Access Compliance Report

Public Rights-of-Way

(Pedestrian Signals)

Intersection ID: N/A	Main Street:	Cross Street: N/A	Location: N/A
ADA ID: C0A033417668	Signal Type: Two Push Buttons-APS	Overall Compliance: No	Severity Score: BTN 1:N/A BTN 2: N/A No BTN: N/A
Codes/Mitigation Info/Possible Solution		Field Measurements/Component Compliance

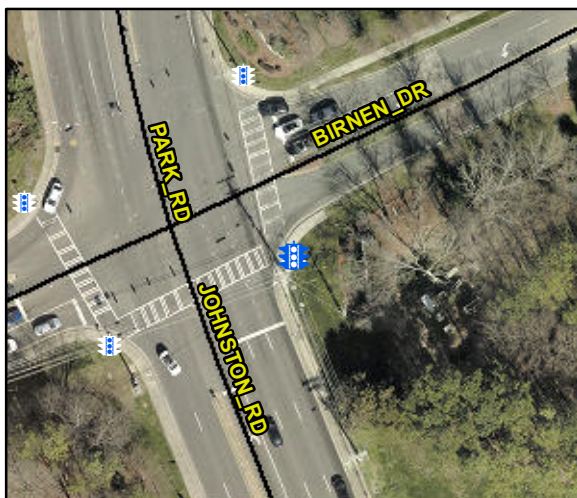
Possible Solutions: Replace Signal Push Button With APS Button on New Post. Remove & Relocate Sign.

PROW/ADA: TMUTCD 4e.08, R404.2, R404.3, R406.2, R404.7.3,
